RECORD PLANS

MIDDLEBURY–WEYBRIDGE
BHO 1445(33)

PROPOSED IMPROVEMENT
BRIDGE PROJECT
TOWNS OF MIDDLEBURY AND WEYBRIDGE
COUNTY OF ADDISON
T.H. NOS. 3 AND 5 (CLASS 2) BRIDGE NO. 1

PROJECT DESCRIPTION: REHABILITATION OF THE PULP MILL COVERED BRIDGE CONSISTS OF REPLACING THE DETERIORATED BRIDGE MEMBERS, INSTALLATION OF NEW SIDING AND A NEW METAL ROOF, SUBSTRUCTURE REPAIRS, INSTALLATION OF APPROACH RAILING AND RECONSTRUCTION OF ROADWAY APPROACHES.

FILE NAME: z06J086sht11ay.dgn
PROJECT LEADER: M.D.SARGENT
DESIGNED BY: J.BICJA
T.H. NOS. 3 & 5 ROADWAY PLAN

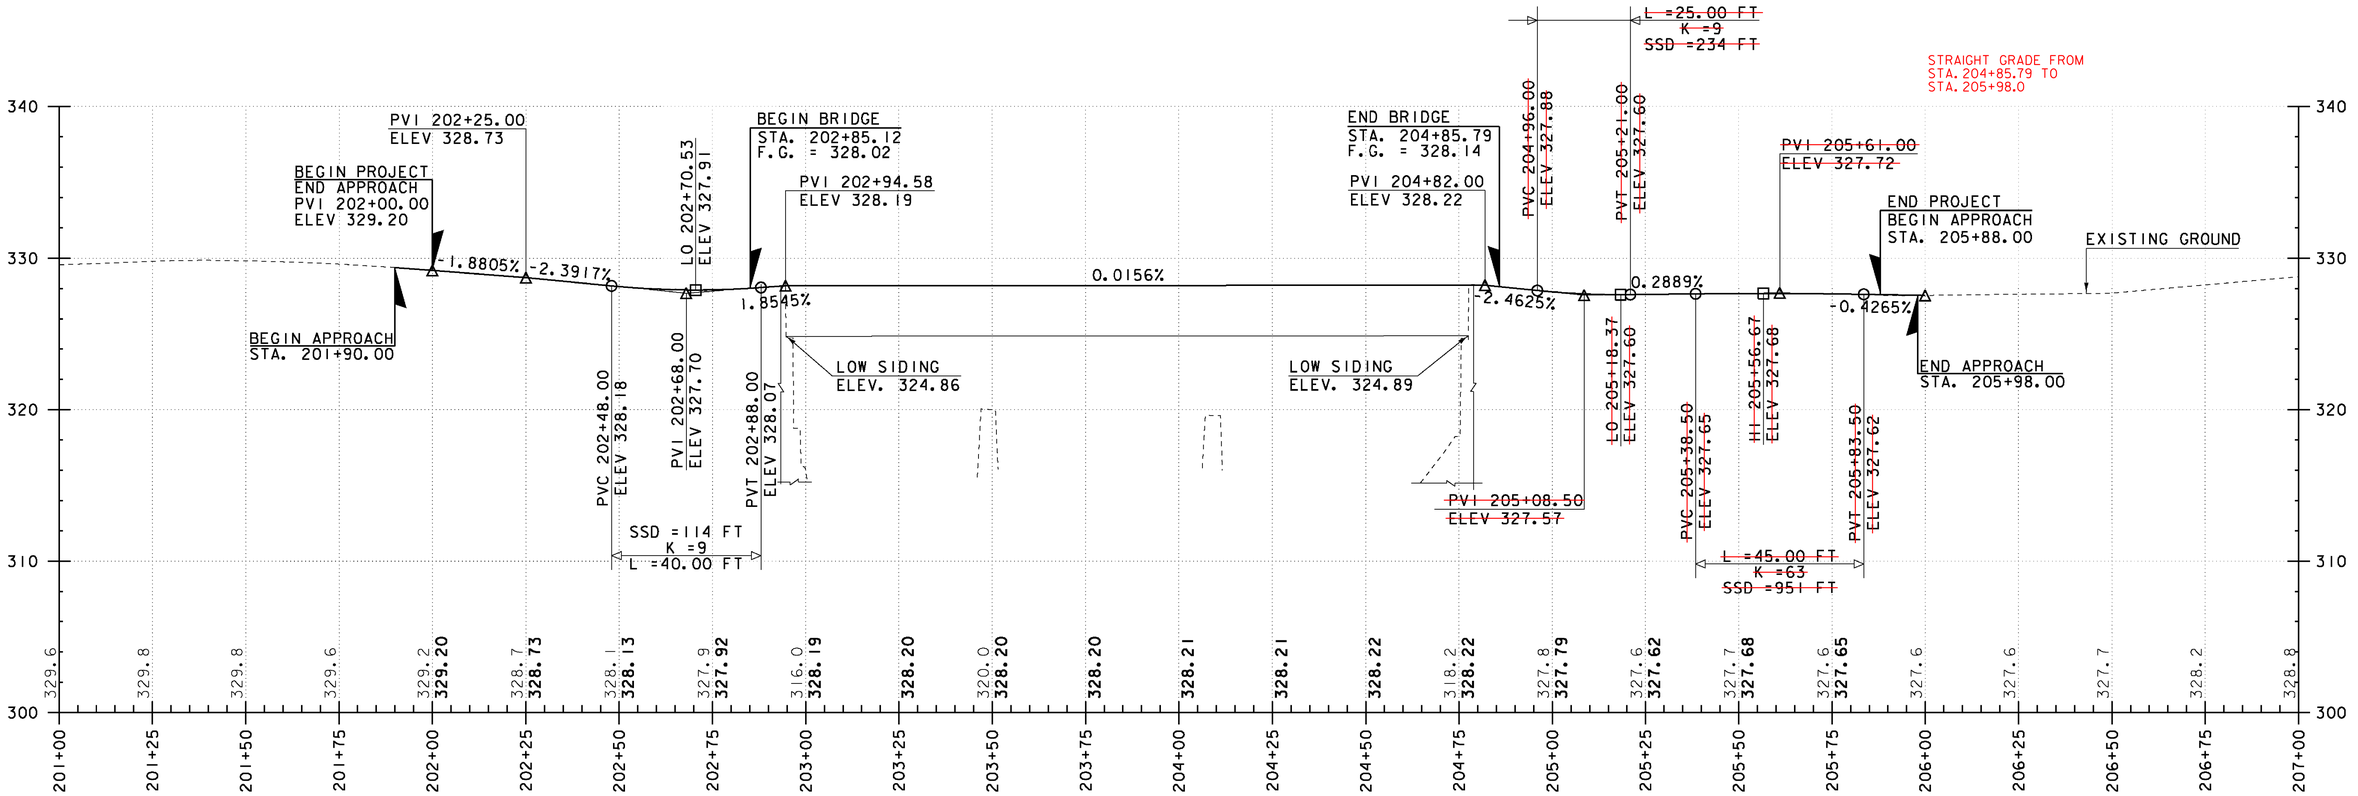
1. ~~STA. 205+17.39 RT. 8.82' - STA. 205+22.93 LT. 23.88'~~
   ~~CONST. PRECAST CB W/CAST IRON GRATE~~
   ~~(ADJUST AS NECESSARY TO PROVIDE 12" MIN. CLEARANCE TO EXISTING WATER MH)~~
   ~~INV. OUT ELEV. 320.58~~
   ~~GRATE ELEV. 327.29 (SLOPE PAVEMENT TO DRAIN TO GRATE)~~
   ~~CONST. 30'x18" DRAINAGE PIPE (SEE QUANTITY SHEETS FOR ALLOWABLE PIPE OPTIONS)~~

2. ~~STA. 205+22.93 LT. 23.88' - STA. 204+72.47 LT. 20.11'~~
   ~~CONST. PRECAST MH W/CAST IRON COVER~~
   ~~INV. IN ELEV. 320.43~~
   ~~INV. OUT ELEV. 319.93~~
   ~~COVER ELEV. 327.61~~
   ~~CONST. 54'x18" DRAINAGE PIPE W/END SECTION (SEE QUANTITY SHEET FOR ALLOWABLE PIPE OPTIONS)~~
   ~~INV. OUTLET ELEV. 319.66~~

3. STA. 202+42.3± RT. - STA. 202+~~93.3~~ 90 LT
   REPLACE EXIST. UNDERDRAIN WITH 6" UNDERDRAIN PIPE AND CONNECT TO EXIST. UNDERDRAIN. CONST. 6" UNDERDRAIN CARRIER PIPE (SEE NOTE 2 ON SHEET 7)
